Conway Planning Commission
STAFF REPORT

1A NORTH WOODS ESTATES SUBDIVISION PRELIMINARY SUBDIVISION

CONWAY CITY PLANNING DEPARTMENT REVIEW NORTH WOODS ESTATES PRELIMINARY PLAT SUBMITTED BY HAWKS INVESTMENTS

CONWAY CITY PLANNING DEPARTMENT REVIEW CAMBRIDGE VILLAGE PRELIMINARY REPLAT OF LOT 7B NORTH MARKET PLAZA SUBMITTED BY: CITY OF CONWAY JULY 30, 2015

NORTH WOODS ESTATES

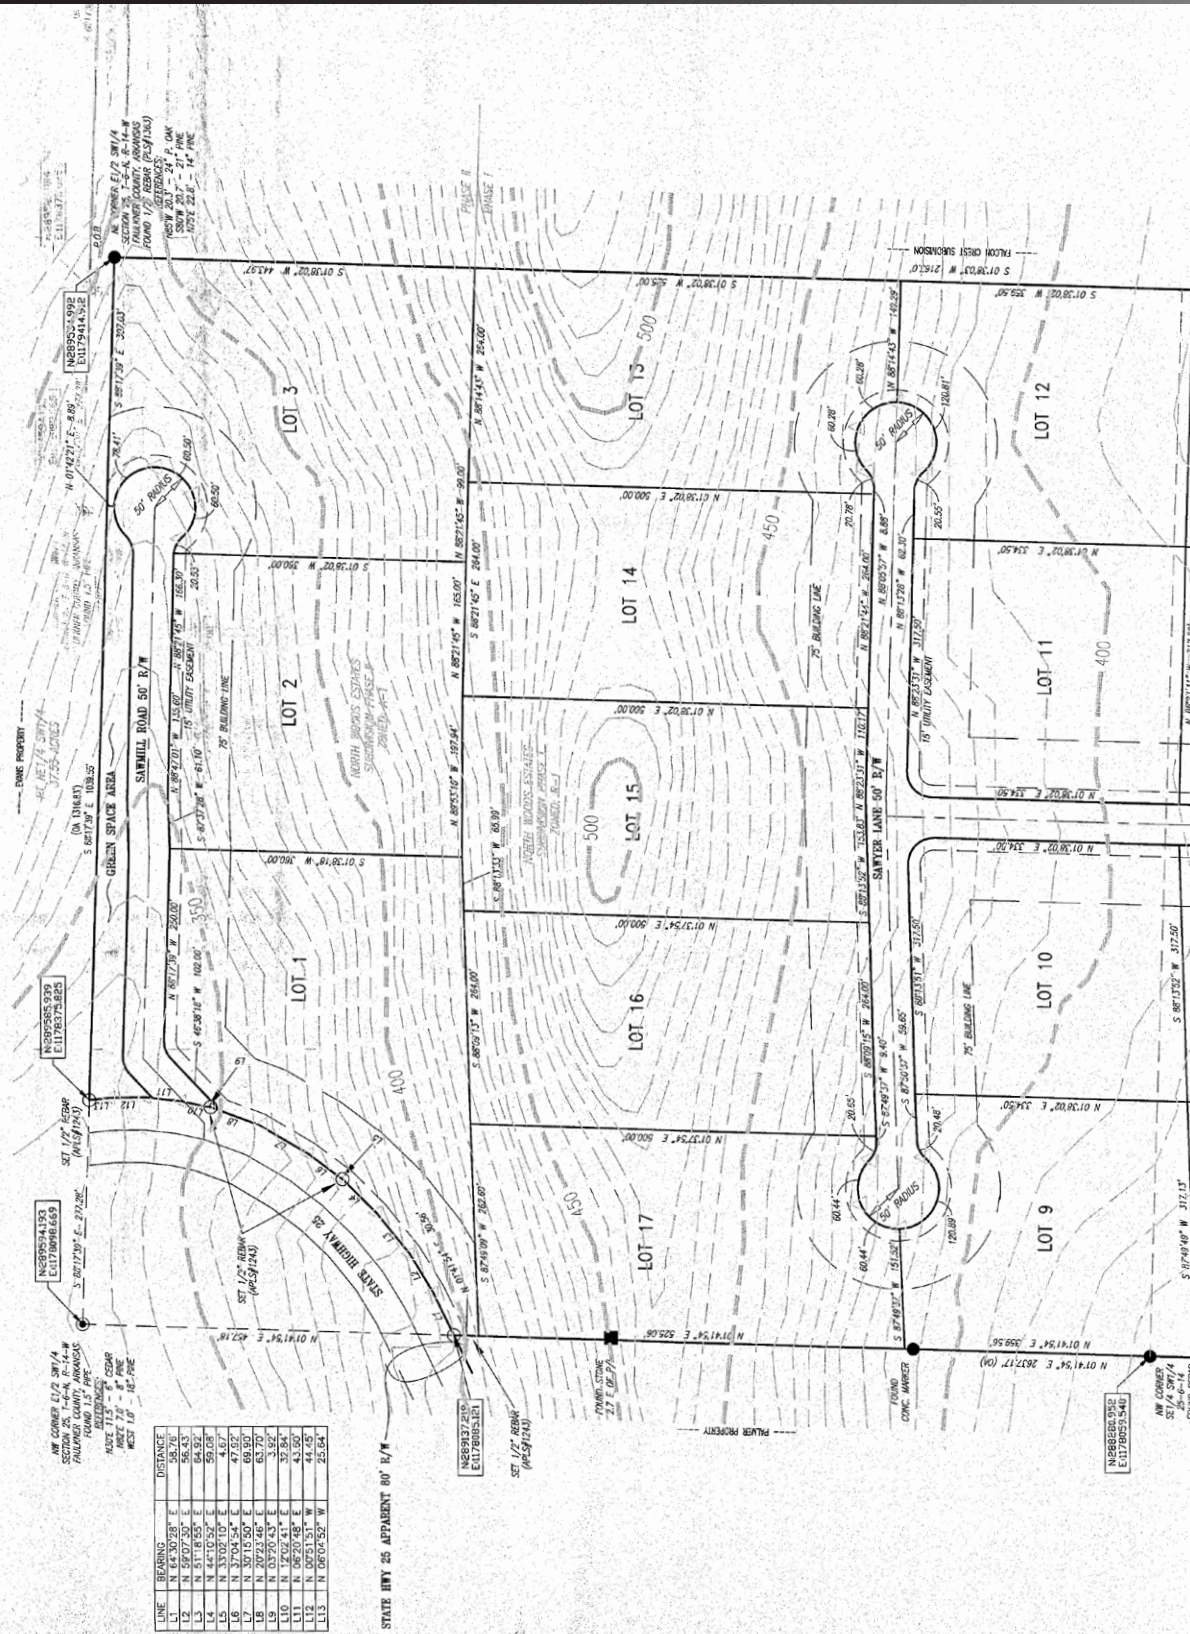
This plat has a lack of street connectivity and other technical issues regarding street design; the angled entrance street connection to Highway 25 and required cul-de-sac diameters. The Commission may consider the subdivision as submitted or require a resubmit of the design for review at the September meeting.

1. A legal description of the property with exact boundary lines, bearings and distances is needed. *The Legal does not match the boundary measurements.*
2. If any portion of the land being subdivided is subject to flooding, the limit of such flooding shall be noted and the appropriate 100 year floodplain and/or floodway shall be identified. *Drainage Plans should be provided.*

4. Street names that are not similar to existing street names are needed for all proposed streets. *Consideration to change Sawyer Street to Chablis.*
5. Proposed easements are needed.

6. Land to be used for purposes other than residential must be shown. *Change Green Space Area to Drainage Easement.*
7. The source of water supply must be shown.

31. Every subdivision or replat shall be served by a publicly dedicated street system that meets the access requirements of the Subdivision Ordinance. Additional Access is needed for Phase I or Variance Request should be submitted.

35. *The proposed street layout should be integrated with the street system in the adjoining subdivisions. Sawyer Lane should be extended to connect with Chablis Drive right of way in Falconcrest Subdivision. The Planning Commission must approve this lack of connectivity or the condition must be corrected.*

36. Proposed through streets shall be extended to the boundary lines of the tract to be subdivided/replatted unless the Planning Commission has determined that such extension is not necessary or desirable for the coordination of the layout of the subdivision/replat with existing and adjoining parcels. *Sawyer Lane should be extended to connect with Chablis Drive right of way in Falconcrest Subdivision. The Planning Commission must approve this lack of connectivity or the condition must be corrected.*

38. Proper access in the form of stub streets or temporary deadend streets shall be provided to adjacent unplatted property unless, in the judgment of the Planning Commission, topographic conditions or physical constraints preclude reasonable provision of such access or alternate routes are or will be available in the future. *Sawyer Lane should be extended to connect with Chablis Drive right of way in Falcon Crest Subdivision. The cul-de-sac at Lot 3 Phase II should be designed to allow connectivity to the north. The Planning Commission must approve this lack of connectivity or the condition must be corrected.*

41. Any cul-de-sac over 750 feet in length must have fire department approval.
42. A street that does not extend to the boundary of a subdivision shall be no closer than 50 feet to that boundary. *Lot 3, Phase II Cul-De-Sac should connect to property to the North. The Planning Commission must approve this lack of connectivity or the condition must be corrected.*

43. Cul-de-sac turnarounds shall have a right-of-way diameter of 120 feet and a pavement diameter of 96 feet. Measurements assume back of curb to back of curb for a roll curb. Cul-de-sacs are shown with a 100 foot right of way. These cul-de-sacs should be enlarged to a 120 foot ROW diameter to meet fire code.

44. Street intersections shall be laid out as nearly at right angles as possible. No intersection shall be at an angle of less than seventy-five (75) degrees. Where residential streets intersect with other residential, collector or arterial streets, the curb radii at the intersection shall not be less than twenty-five (25) twenty-eight (28) feet. *Connection to Hwy 25 on the South should be corrected. The Planning Commission must approve this street intersection angle and radius or the condition must be corrected.*

47. Utility easements as required by Conway Corporation are needed.
48. Drainage easements as required by the City Engineer are needed.
49. Where possible, pedestrian trail and pathway systems shall link open space corridors through major utility, drainage and other easements and another easement for the pathways shall be established within that easement. *If the lack of connection from Sawyer Lane to Chablis Drive is approved, a Pedestrian Pathway easement is needed and should be constructed from Sawyer Lane to Chablis Drive connecting Falcon Crest Subdivision to the East. The Planning Commission must approve this lack of connectivity or the condition must be corrected.*

CAMBRIDGE VILLAGE
REPLAT OF LOT 7B NORTH
TO THE CITY OF CONWAY, FAULKNER COUNTY, ARKANSAS

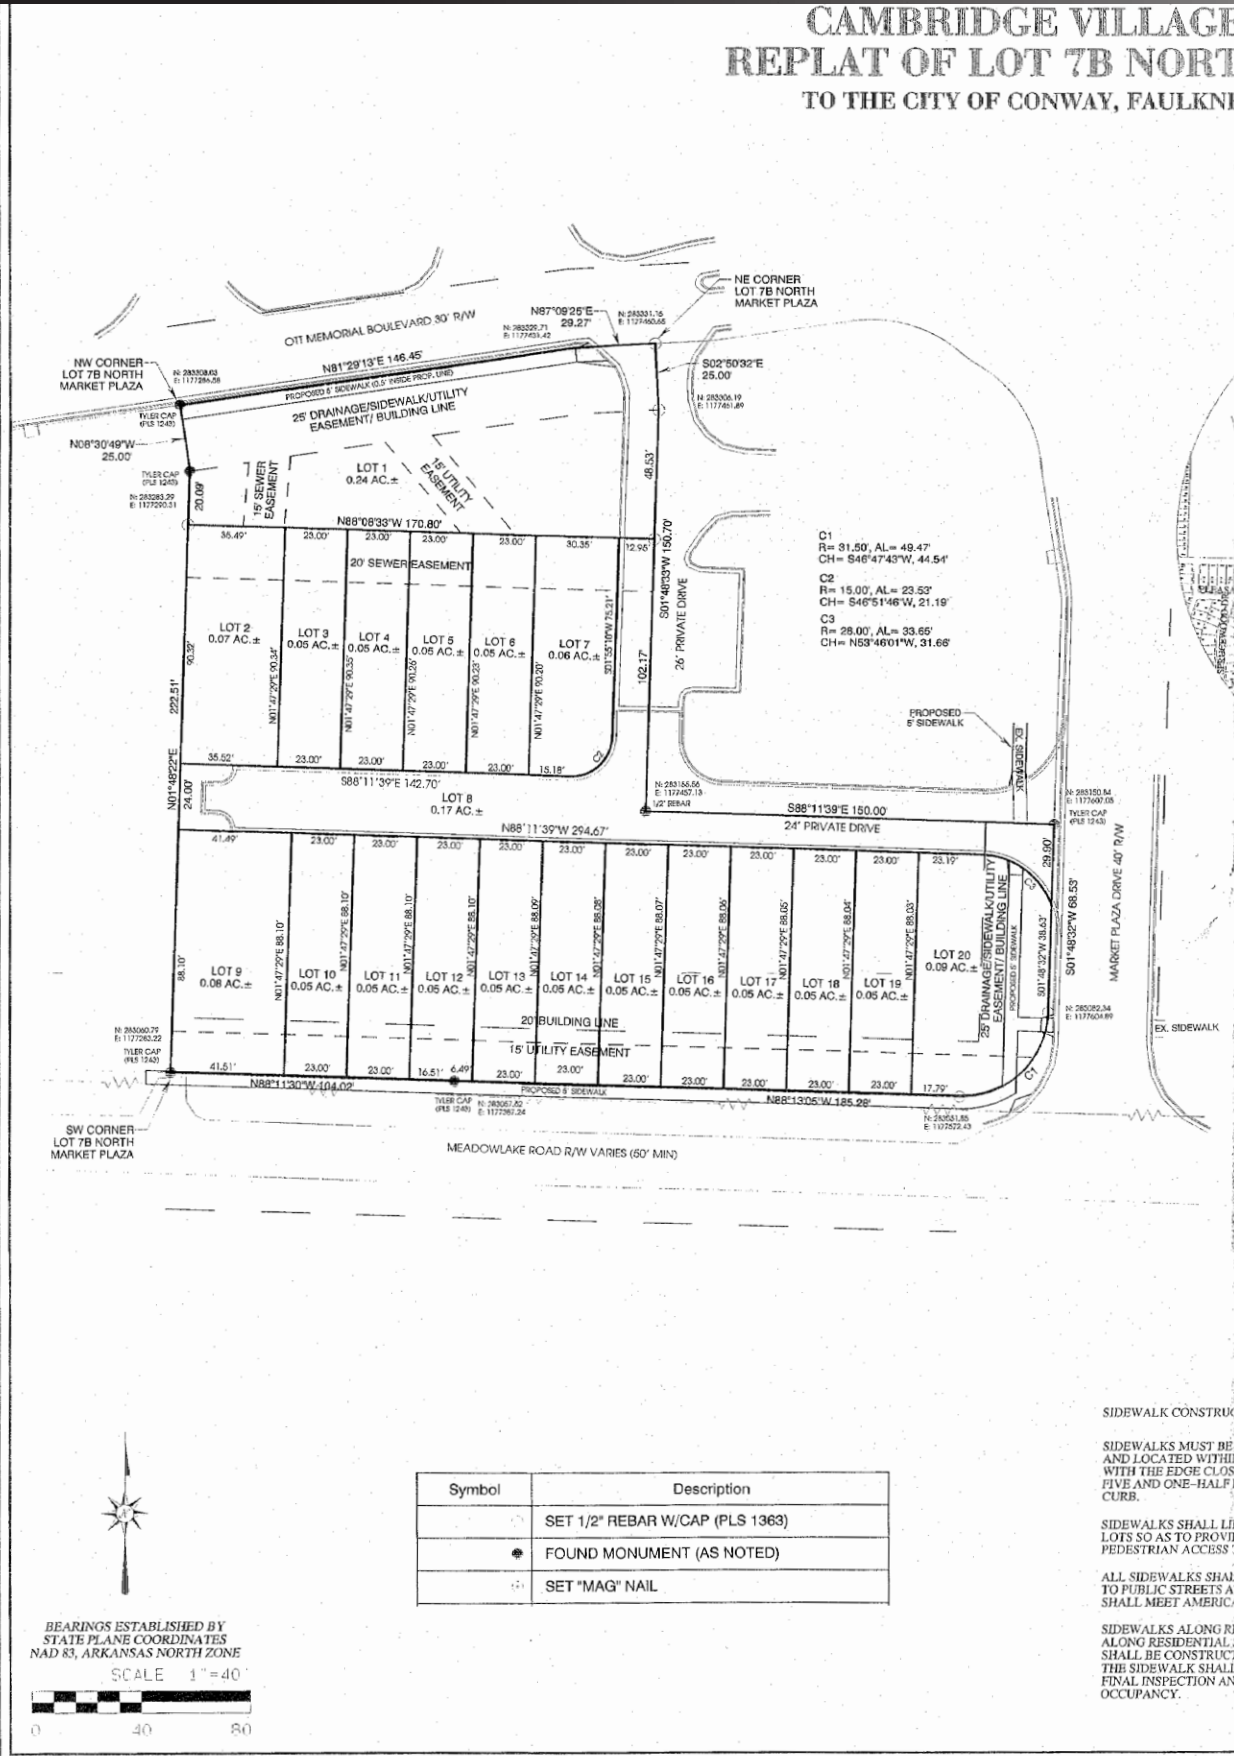
14. A minimum lot size of approximately .05 acre in area shall be allowed as per the intent of the PUD Final Development Plan. *The Planning Commission must approve this lot area or the condition must be corrected.*

15. A minimum lot depth of approximately 88 feet shall be allowed as per the intent of the PUD Final Development Plan. *The Planning Commission must approve this lot depth or the condition must be corrected.*

16. A minimum lot width of approximately 23 feet shall be allowed as per the intent of the PUD Final Development Plan. *The Planning Commission must approve this lot width or the condition must be corrected.*

17. The minimum building setback (building line) shall be no less than 20 feet from the Meadowlake Road right-of-way. This is a 5 foot reduction from the original PUD Final Development Plan. All other setbacks shall be 0 feet with the exception of the 25 foot setback along North Market Plaza Drive. *The Planning Commission must approve these setbacks or the condition must be corrected.*

Preliminary Plat

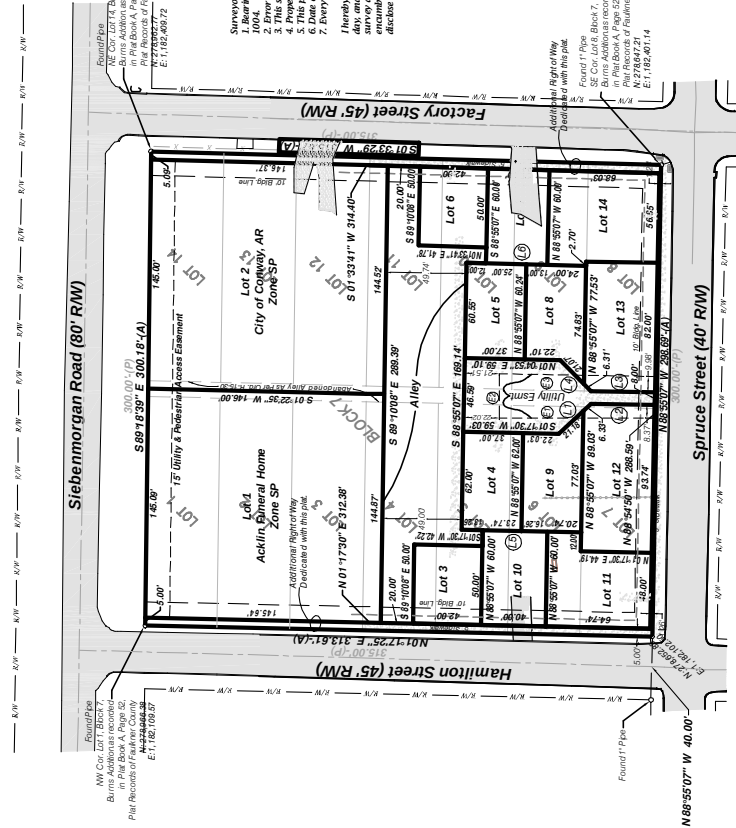
4. A vicinity map showing the location and acreage of the subdivision/replat must be shown. *Add Acreage*
5. A legal description of the property with exact boundary lines, bearings and distances is needed. *Add Acreage to the end.*

8. The layout of all proposed sidewalk systems are needed, along with relevant dimensions and bearings. *Add 6' sidewalk inside the 15' Utility & Pedestrian Access Easement on the North Boundary Line*

9. Proposed easements are needed. *Add Pedestrian Access Easement to the Center Courtyard Area. Add Pedestrian Access Easement to the 15' Utility Easement on the North Boundary line of lots 1 & 2*

10. Any proposed open space must be shown. *Hash Courtyard Area as designated Open Green Space*
11. The Certificate of Preliminary Plat Approval is needed. *Change "Final" to "Preliminary"*

13. The development plans shall include and identify a prepared and dedicated flowage path or floodway that will accommodate a one hundred (100) year frequency storm event across and through the development. The floodway shall be uniformly graded along the length of the floodway such that water will not pond or accumulate on the surface due to humps or depressions along the route. Computations for the quantity of storm water runoff, sizing of the floodway and elevation of the one hundred (100) year flood shall be prepared by a registered professional engineer and submitted to the City Engineer for review and approval. The computations shall be made using usual and accepted methods and procedures as approved by the City Engineer. A floodway will not be required where less than five (5) acres of adjacent lands drains onto the developed property and the total drainage area is less than five (5) acres. *Add note to Plat that property does not lie in a 100 yr Flood Plain.*

17. All alleys must be paved with concrete or asphalt with the center depressed to carry water. *Add an Alley Notes Section and add this item to that note.*
18. Curbs and gutters are not required for alleys. *Add to Alley Notes Section*
19. Alleys must have a paved width of no less than 15 feet. *Add to Alley Notes Section*

24. Lots must abut upon a public street except where private streets are approved by the Planning Commission in Planned Unit Developments or where a dedicated access easement 25' in width in C-1, C-3 or O-1 zones has been approved by the Planning Commission. Street frontage width must comply with the Zoning Ordinance requirements. *An Amendment to the Specific Plan is needed for lots that do not abut a public street.*

25. Minimum lot depth must conform with the requirements of the Zoning Ordinance. *An Amendment to the Specific Plan needed for Pocket Neighborhood Style Arrangement.*

26. The minimum building setback (building line) shall be no less than 25 feet from the right-of-way of the front street, or as required by the Zoning Ordinance. *Add Building Setback of 18' to north boundary line along lots 1 & 2. Amendment to the Specific Plan needed for 5' Building Set back on lots 3 thru 14 bordering public streets.*

27. All existing buildings must be shown to meet the minimum setback requirements from all lot lines or they must be modified or moved to meet those setback requirements. Amendments to the Specific Plan required for reduced setbacks as needed for lots 3-14. *Add Building Setback of 18' to north boundary line along lots 1 & 2.*

28. At the Planning Commission's discretion, a fence or wall may be substituted for the planting easement and planting screen, but access is denied in the same manner as for the planting easement with the same requirements for noting the restriction. *Add a 5' Planting Screen Easement running along the southern boundary of the proposed Alley.*

30. Sidewalks along streets on unbuildable, green space, and other permanently vacant lots will be the responsibility of the developer. *Add to Sidewalk Note #4: City of Conway responsible for all public sidewalk construction on Block 7.*

31. Aside from the required sidewalks along collectors and arterials, an, internalized pedestrian circulation system in the form of pathways, either along streets or not, may be constructed within subdivisions upon the request of the applicant and the approval of the Planning commission. The system may be allowed to deviate from the construction requirements set out otherwise in this section, as long as the minimum dimensional requirements are met. *Sidewalks in common courtyard area require approval by Planning Commission.*

33. Sidewalks must be a minimum of five feet wide and located within the public right-of-way, with the edge closest to the street located five and one-half feet from the back of the curb. Sidewalks are not required to be constructed in a straight line, if such straight line construction would damage trees, or if an aesthetic effect is desired and the Planning Commission approves. *Show proposed 6' sidewalk inside north boundary line across lots 1 & 2.*
